Meeting of the
Scotts Valley City Council
In-Person and Remote Access
Date: October 2, 2024
Time: 6:00 PM

The proposed project includes demolition of the existing commercial buildings and construction of a three-story commercial redevelopment which consists of one 52,822 square feet (sf) building (Attachment 2: Sheet A2.1 Site Plan). This building would include 10,465 square feet of professional and administrative office space, and 42,357 square feet of storage for up to 227 user spaces. The first and second floors of the building will be bifurcated by an internal drive aisle that allows vehicles to park for loading and unloading. The third floor will be continuous over the internal drive aisle. There will be three office spaces on the first floor, six office spaces on the second floor and six office spaces on the third floor, although it is important to note that while Sheet A2.2 of the plan set shows a total of 13 office/storage spaces, the project, as proposed, would allow the applicant to demise the interior space into 227 individual storage spaces, if desired. The project would provide 54 parking spaces located on the north and south extents of the project site, and along a c

Date:	10-06-23
Scale:	1" = 20'
Drawn:	TC/JB
Job:	338-40
Sheet:	C1.1
Of 12 Sheets

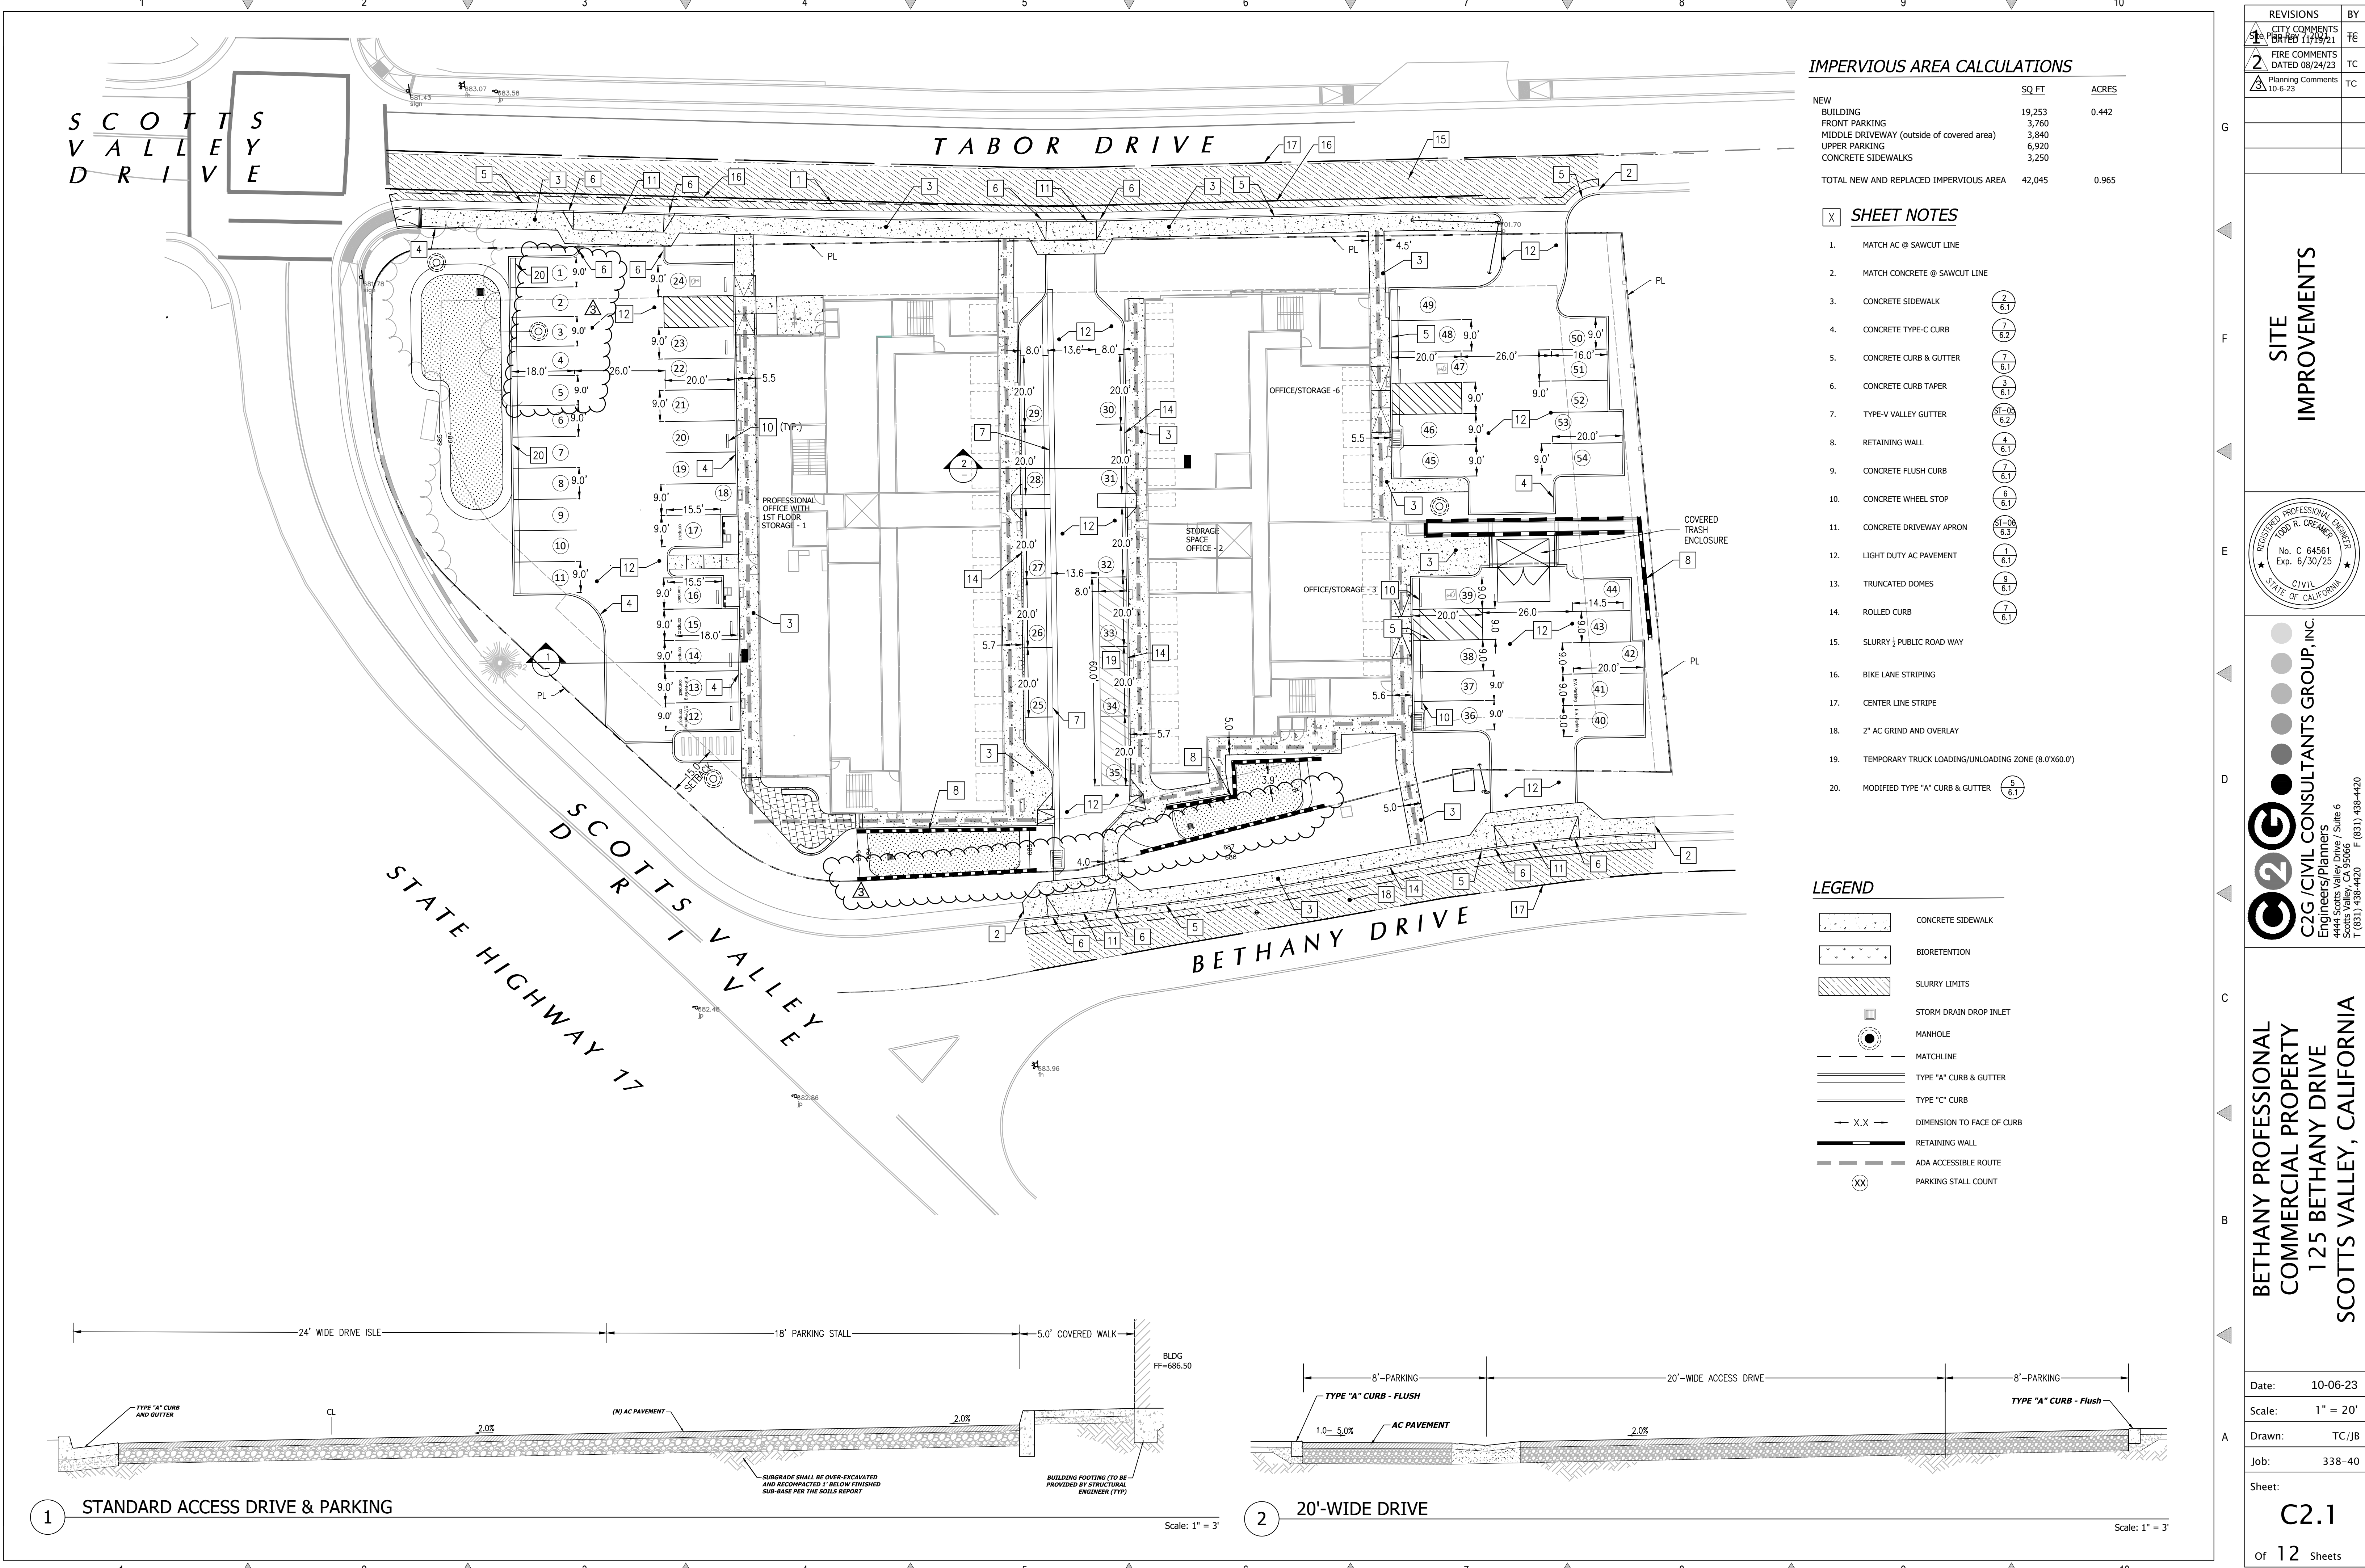
The Planning Department has concerns about the size of some of the parking spaces as well as the overall parking lot design in the rear lot. As shown on Attachment 1: Sheet C2.1 of the plan set, many of the proposed parking spaces do not meet these requirements and many of the parking spaces do not include dimensions to demonstrate compliance. In addition, all of the spaces along the access drive that runs through the building are undersized, measuring only 8' in width.

In addition to the undersized parking spaces, the Planning Department also has concerns about the parking lot design. As shown on Attachment 1: Sheet C2.1 of the plan set, and mentioned previously, parking spaces 39 and 44 would be difficult to maneuver in and out of as the trash enclosure does not allow for adequate turning movements or back up space.

As shown on Attachment 1: Sheet C2.1 of the plan set, the proposed project includes a loading zone located within the internal drive aisle. The drive aisle is 13.6' wide and includes eleven 8' x 20' parking spaces on both sides.

The Planning Department has several concerns about the loading zone. First, Attachment 1: Sheet C2.1 Site Improvements, shows the proposed loading space to be 8'x60', which does not satisfy the Zoning Code requirement of two 12'x45' spaces. Second, when the loading zone is in use, it blocks parking spaces limiting the amount of required parking on site. Third, if the parking spaces were in use when a truck needed to use the loading space, the truck could potentially park in the drive aisle, and this could create queuing problems on and potentially off site. Finally, if a large truck were parked in the loading zone, and the parking spaces on the opposite side were in use, the drive aisle could potentially be blocked, which could also create a queuing problem.

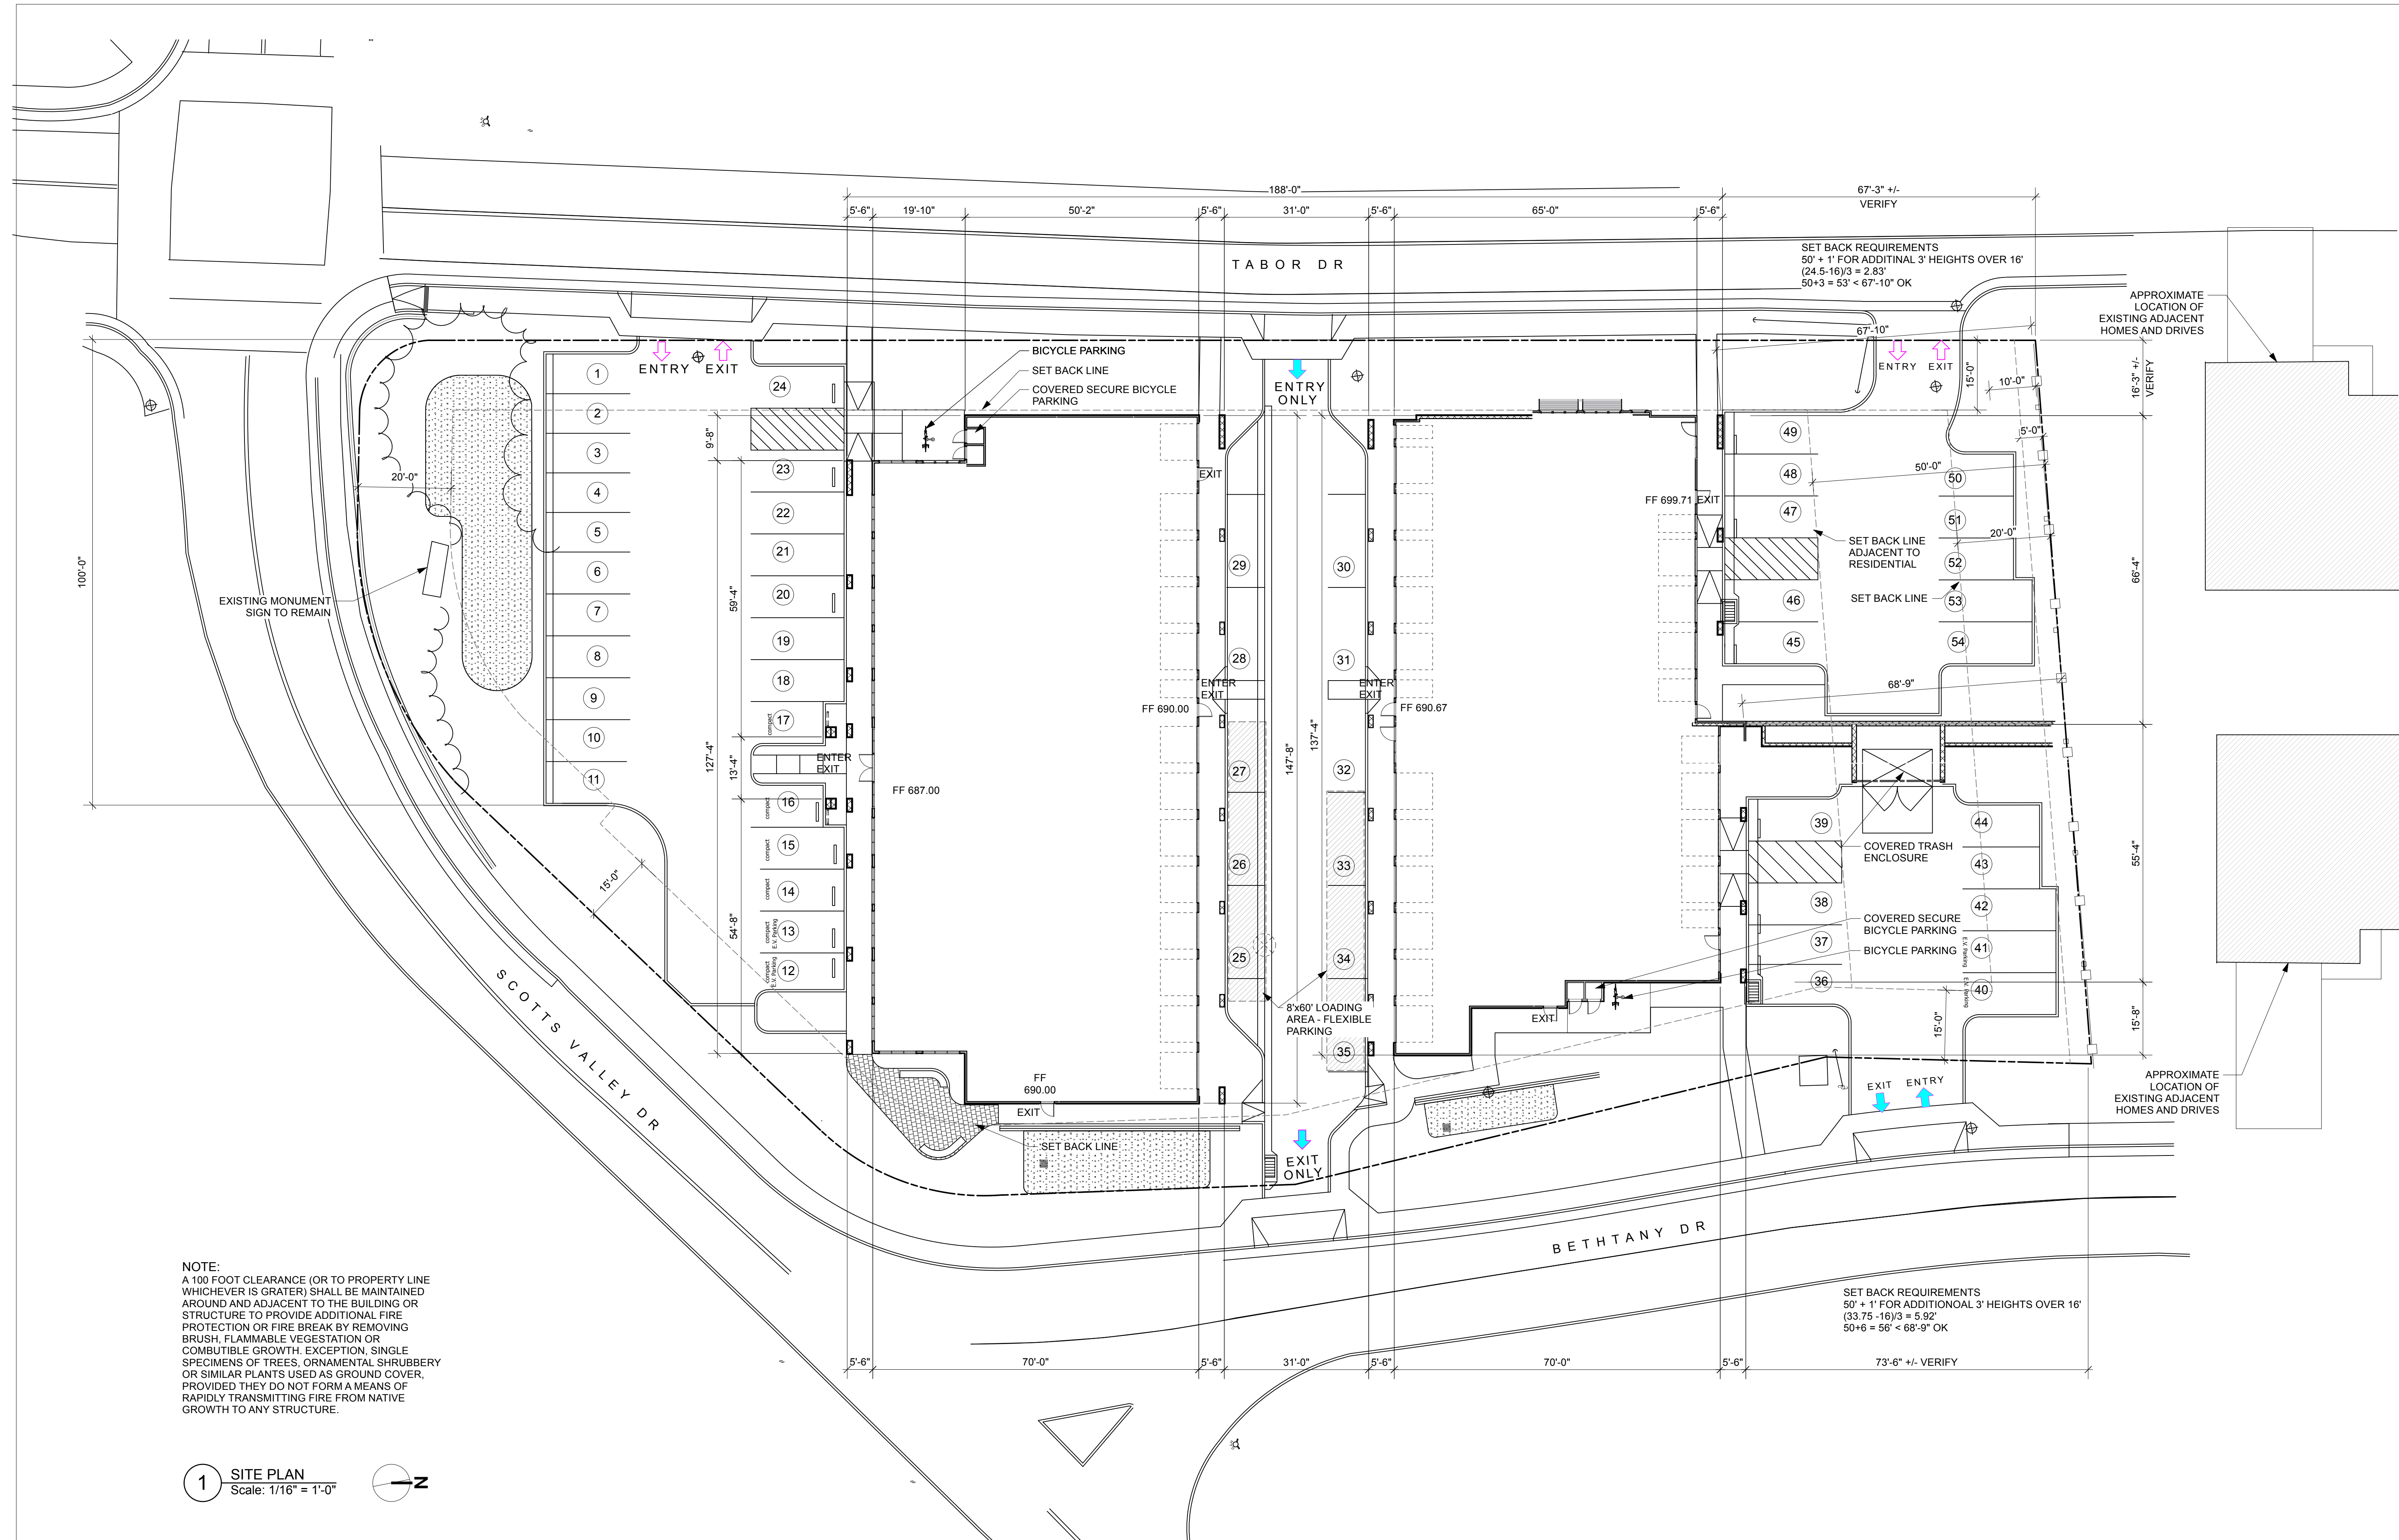
The trash enclosure is located to the rear of the site, within the parking lot, and adjacent to the residential, as shown on Attachment 1: Site Plan, Sheet A2.1.
